## TMC SPECIFICATION NO. S-552

TITLE: GPT-10K H.V. RESISTOR BOARD AND FEEDTHRU

CAPACITOR MODIFICATION KIT (TMC NO. KIT-103)

To decrease resistor dissipation of R816, R819, and R820 by rerouting the current return and deleting the bleeder resistors, and to eliminate voltage breakdown of the P.A. Deck & REG-1 feedthru capacitors by replacing them with insulated feedthru bushing assemblies.

FIGURE 1  
 POWER SUPPLY SECTION, REAR VIEW  
 MODIFICATION PROCEDURE

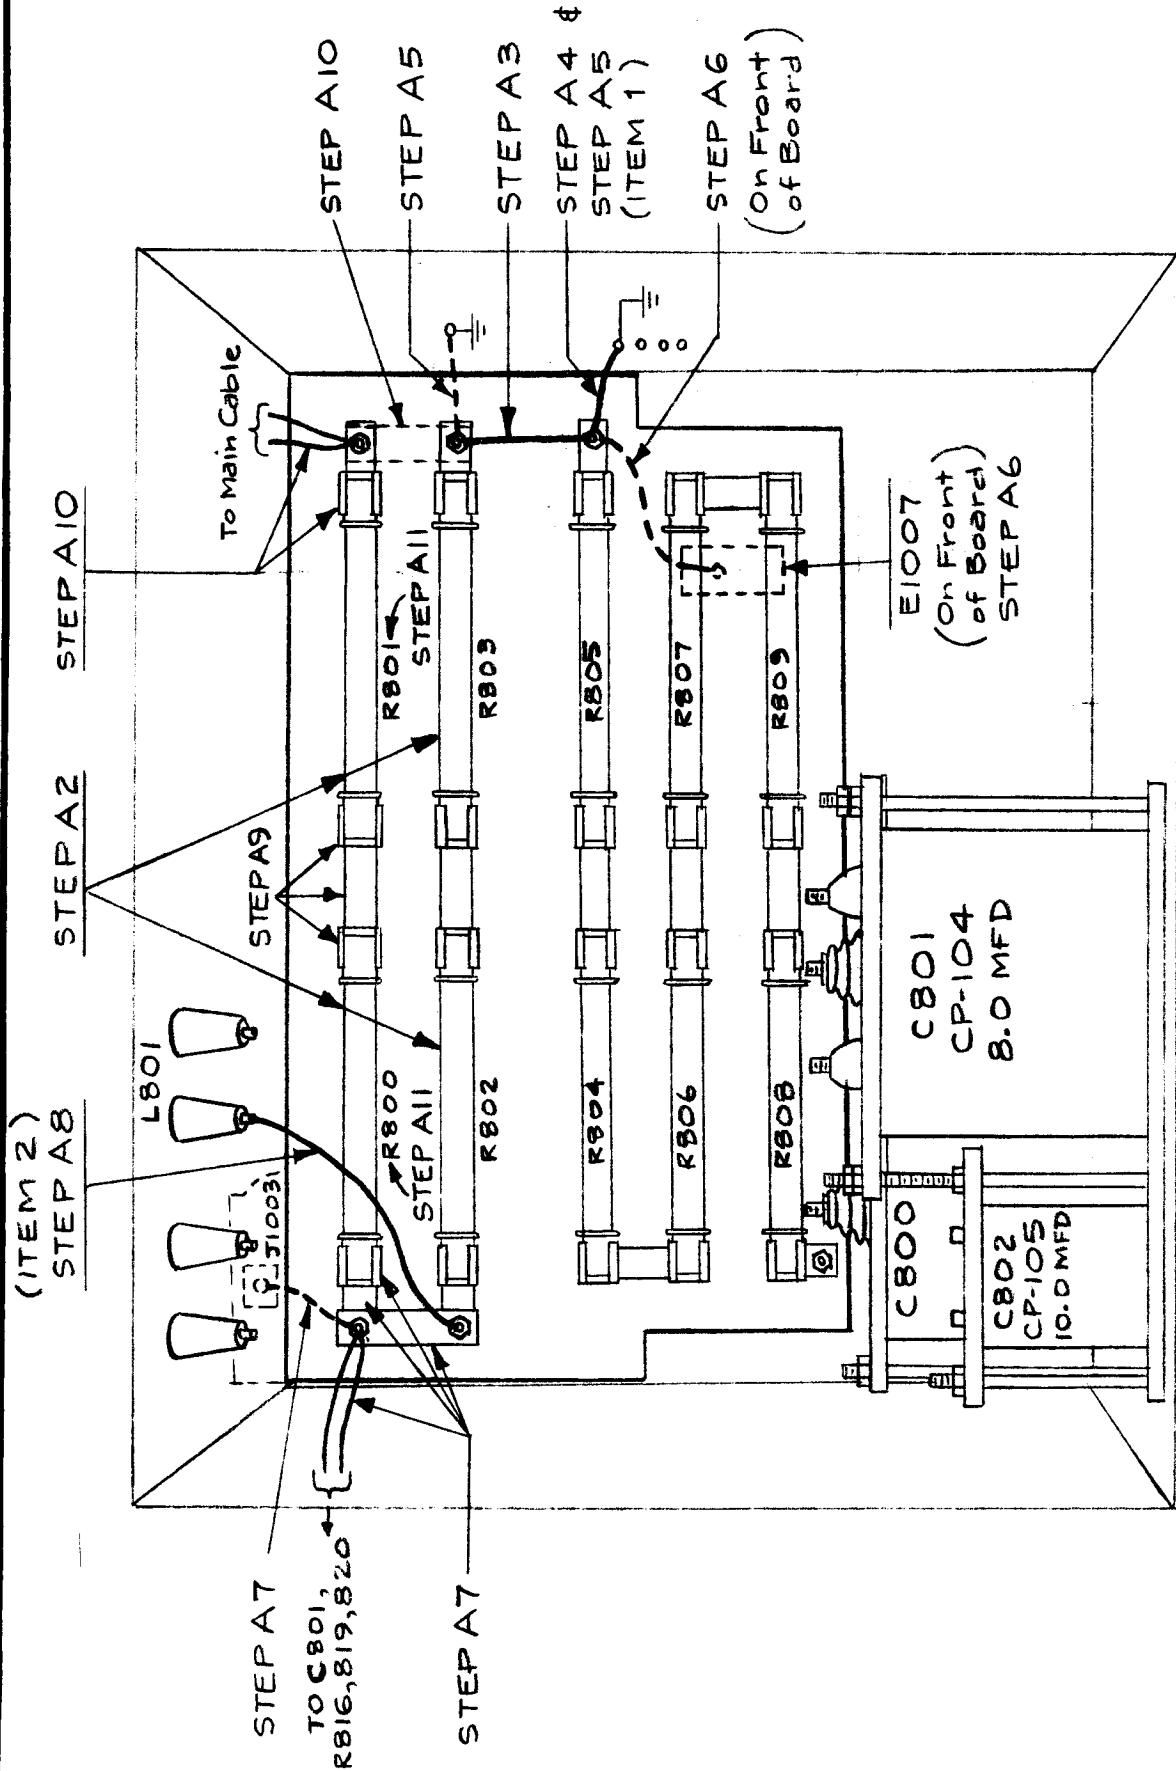
2. Remove resistors, symbol no's. R800, (5K,140W) R801, R802, and R803 (18K, 140W) See Figure 1.
3. Remove jumper between R803 and R805 (Figure 1). This jumper may be found on the Front or rear of the resistor board.

4. If jumper exists between R805 and ground, leave it alone.
5. If jumper exists between R803 and ground, remove it and add new jumper, item 1, from R805 to convenient ground. (On slide Mtg. Screw)

6. Make sure there is a jumper connection between spring contact E1007 and R805. (For ground connection)
7. Remove the two leads, the short connecting plate, and the Resistor Clip from R800. Remove the long connecting plate between R800 and R802. Make sure jumper from J1003 (HV INPUT TO IPA) is connected to R800 connecting plate screw.

8. Add new jumper, item 2, from R802 to L801. Re-Connect the two leads (removed in Step 7) to R800, using the R800 short connecting plate screw. Tighten nuts, etc. to R800 and R802 connections.

FIGURE 2  
FINISHED MODIFIED BOARD

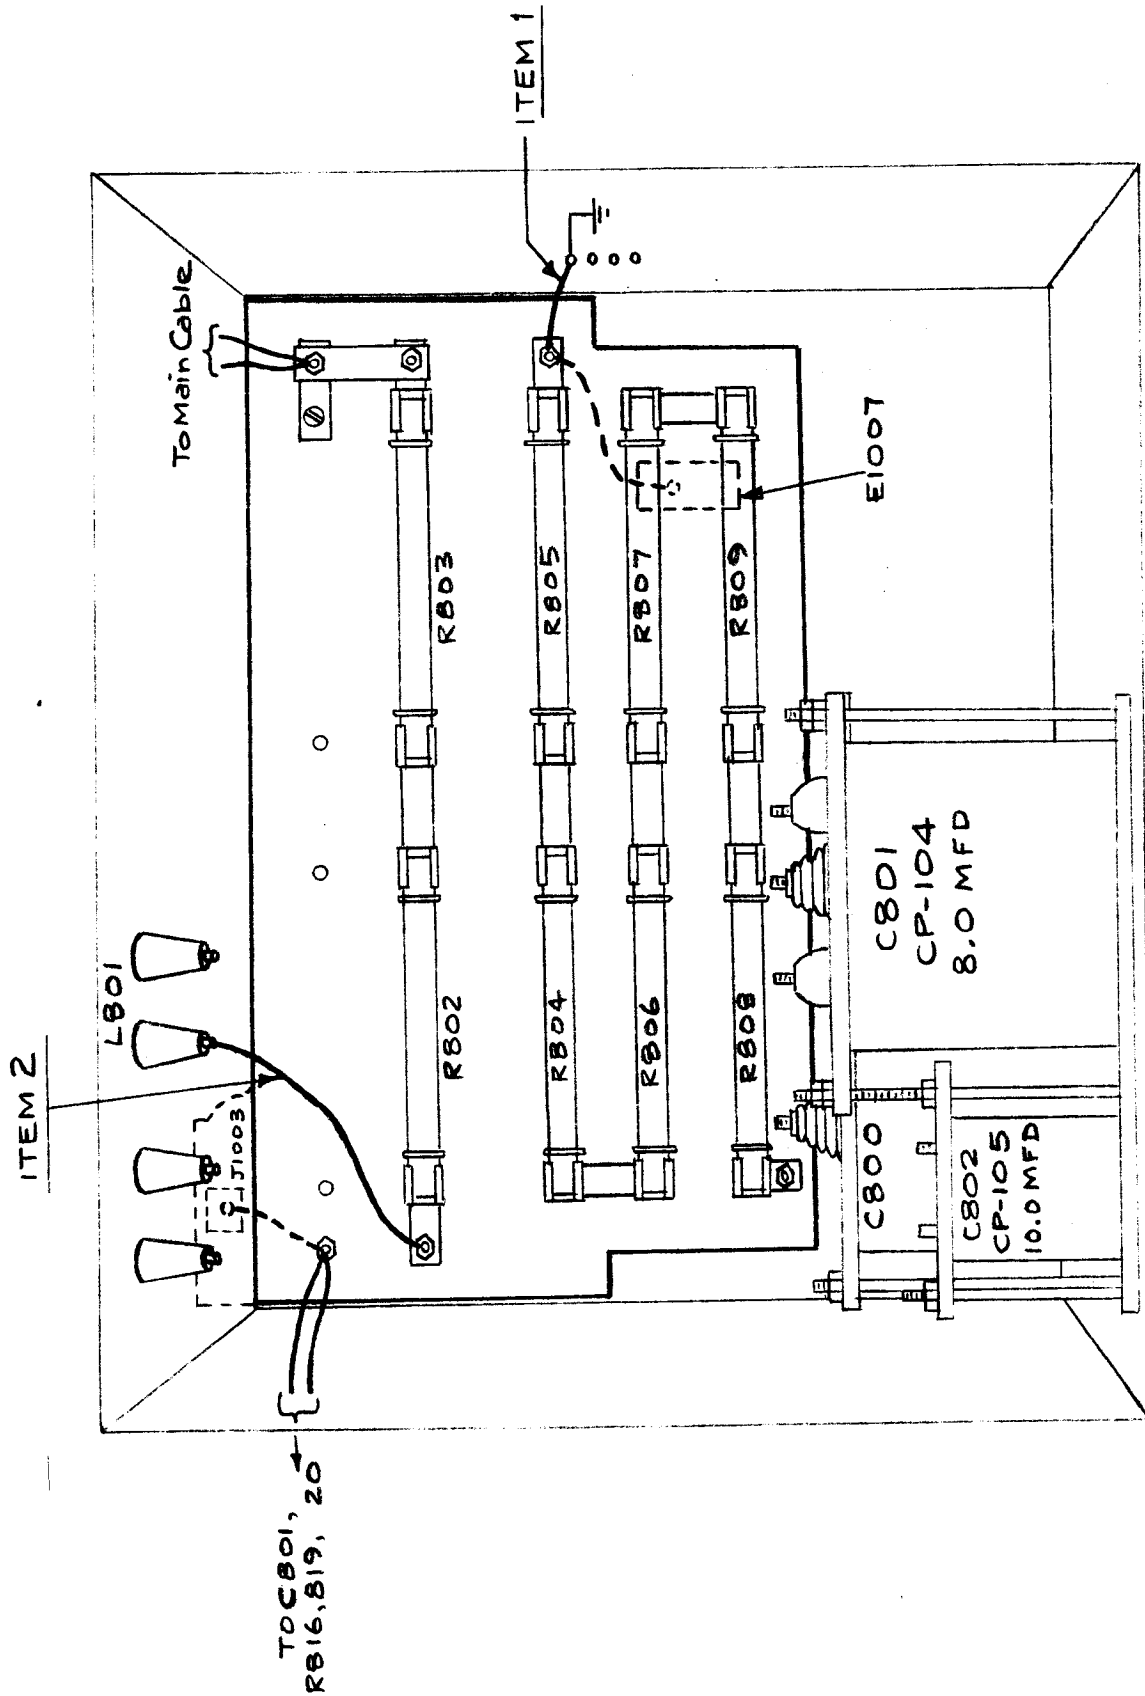
10. Remove white main cable leads from R801. Remove R801 Resistor Clip. Assemble long connecting plate (from step 7) between R801 and R803. Re-assemble white main cable leads to R801. Re-assemble and tighten hardware.
11. Remove the "R800" and "R801" stamping from board.
12. Replace two 18K, 140W resistors (removed in Step 2). Plug one resistor into the "R802" Clips, and one into "R803" Clips.  
(See Figure 2)
13. Check Board Assembly against Figure 2 to see if it conforms.  
See Figure 3 for schematic changes.
14. Replace HVR Drawer and Relay Panel.

FIGURE 5  
RIGHT SIDEPLATE, UNMODIFIED

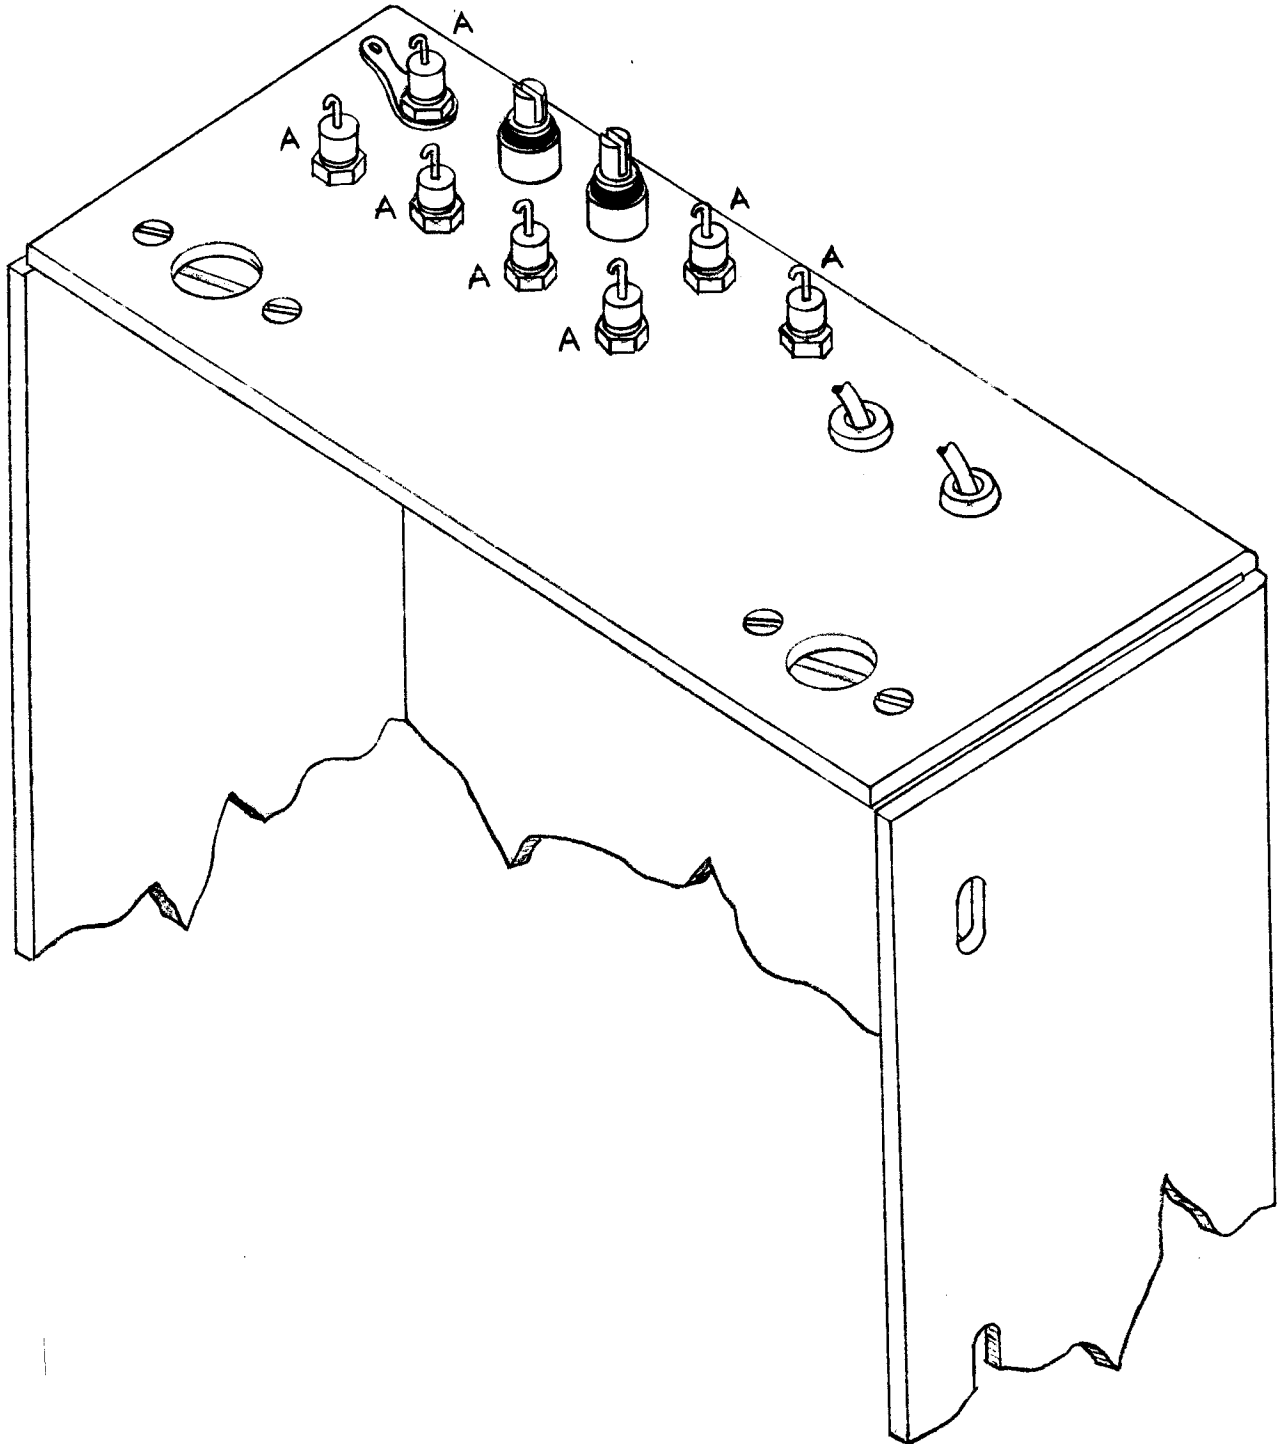
10. Unscrew the two flat head screws and nine binder head screws from the Control Panel and remove the panel. (Figure 4).
11. On the right sideplate, unsolder and remove wires from the top and bottom of the seven feedthru capacitors, symbols C1000, 1001, 1002, 1004, 1006, 1007, and C1008 and the two ground lugs mounted on C1001. (Figure 4 & 5). Using Figure 6, mark the wire colors of leads removed.

12. Remove the seven feedthru capacitors. Discard capacitors. (Figure 5).

The Capacitor listed in Step B11 and B12 are shown below, labeled "A".

RIGHT SIDEPLATE, TOP VIEW,  
 WIRE LOCATION DETAIL

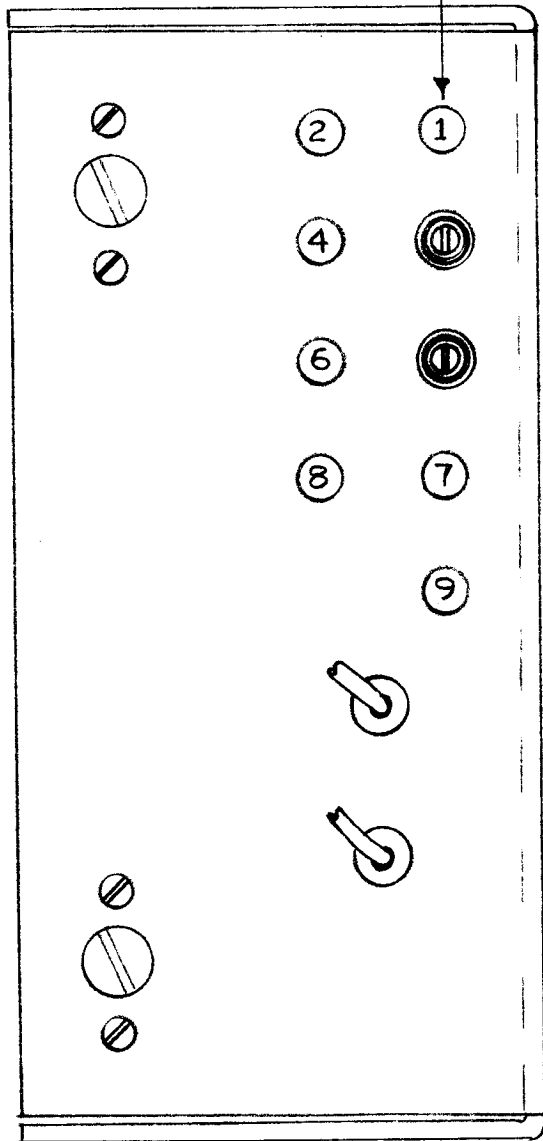
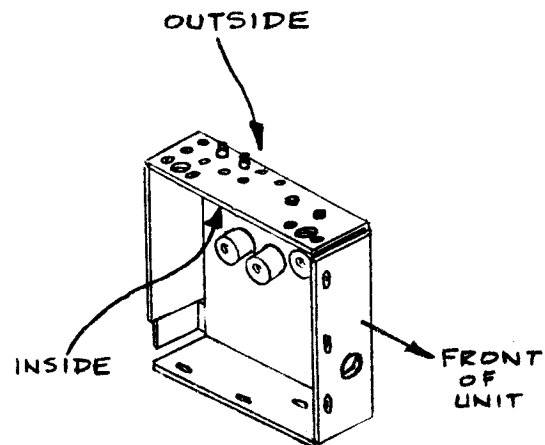
14. Mount the insulated feedthru assemblies onto the sideplate. Be sure to mount the feedthru assemblies in the same holes the corresponding capacitor was in. This can be determined by checking the wire colors against Figure 6.

15. Solder the wires going to the top of the sideplate to the feedthrus. (Use Figure 6 again for correct connections).

WHEN UNSOLDERING WIRES AS PER  
 STEP B11, WRITE COLORS  
 IN CHART. THEN USE  
 FOR RE-ASSEMBLY,  
 STEPS B14 & B15

FIGURE 7  
RIGHT SIDEPLATE, MODIFIED

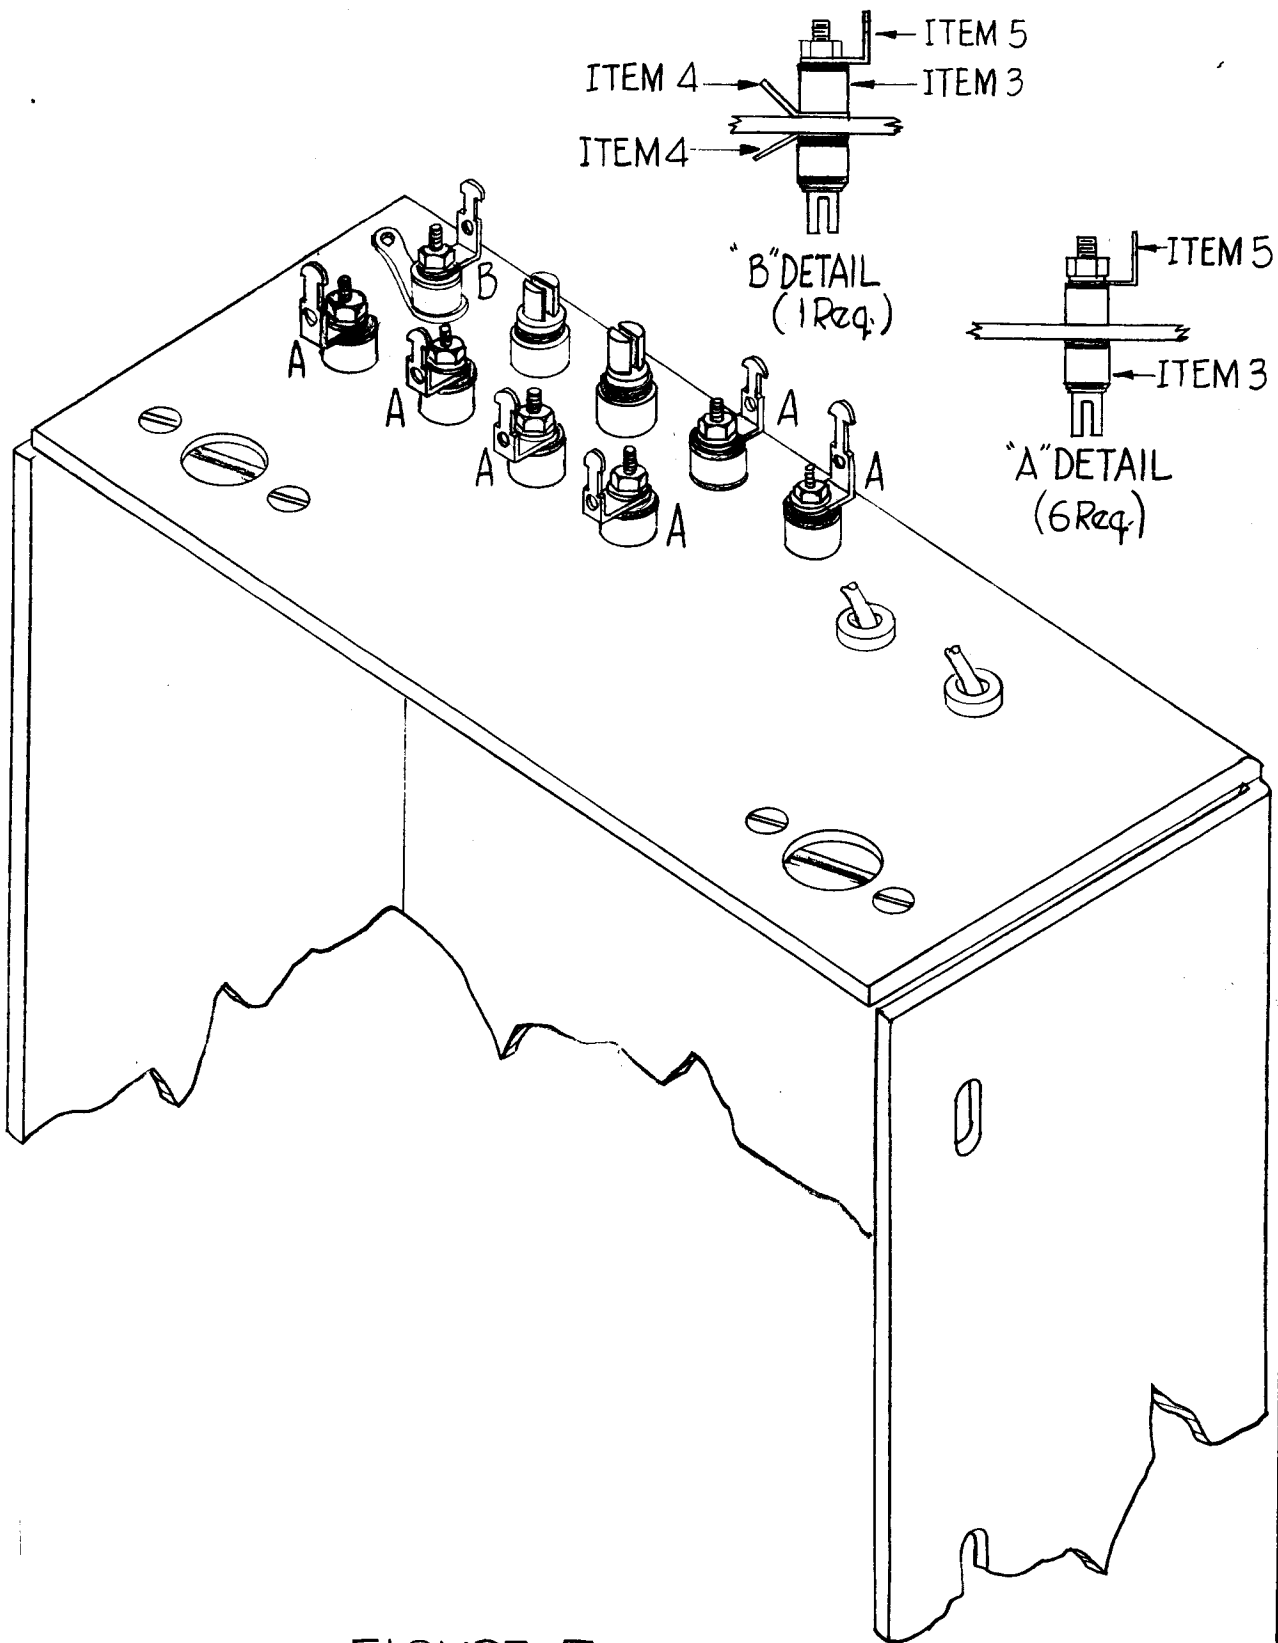
13. Solder the wires (located inside the sideplate) to the slotted ends of the seven new feedthru bushings (item 3).

Do not connect the ground shield. (Figure 7).

IMPORTANT: One feedthru assembly must be mounted with two ground lugs (item 4) and all feedthru assemblies must be mounted with terminal lug (item 5) as shown in Figure 7.

TOP VIEW  
FIG. 9

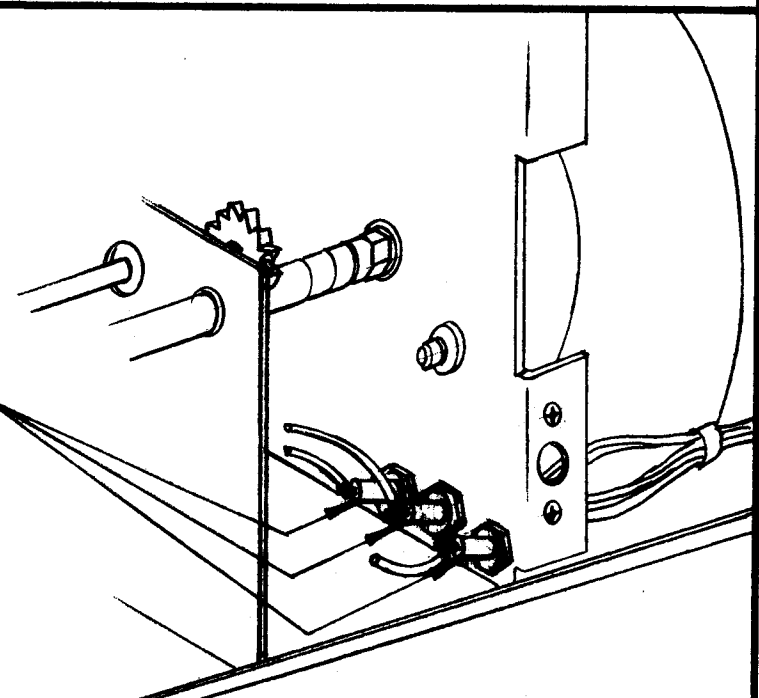
1. Remove the RFC-1 from the transmitter.
2. Remove the top and bottom covers and stand unit on its side.
3. Remove the three feedthru capacitors C244, C280 and C281 from the bottom of the unit as shown in Fig. 8. Be sure to mark the wires for replacement.
4. Remove the three feedthru capacitors; C235, C236 and C256 from the top of the unit as shown in Fig. 9. Be sure to mark the wires for replacement.
5. Replace the six feedthru capacitors with insulated feedthrus, item 3, TE-101-3.
6. Resolder the wires in the proper positions and replace the RFC-1 in the transmitter.
7. Remove the lettering for the capacitors; C235, 236, 244, 256, 280, 281.
8. Put back the covers and replace the RFC-1 in the transmitter.

FEEDTHRU CAPACITORS  
C235, C236 AND C256  
REPLACED BY  
3 FEEDTHRUS TE-101-3

BOTTOM VIEW  
FIG. 8

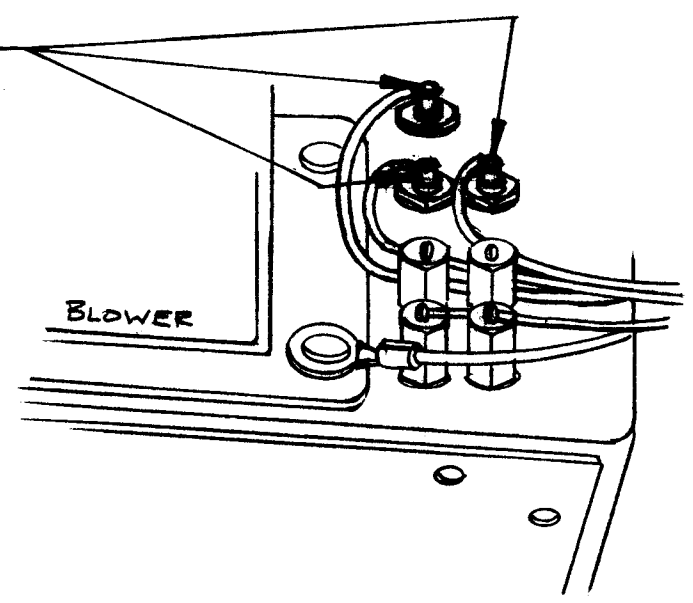
FEEDTHRU CAPACITORS  
C244, C280 AND C281  
REPLACED BY  
3 FEEDTHRUS TE-101-3
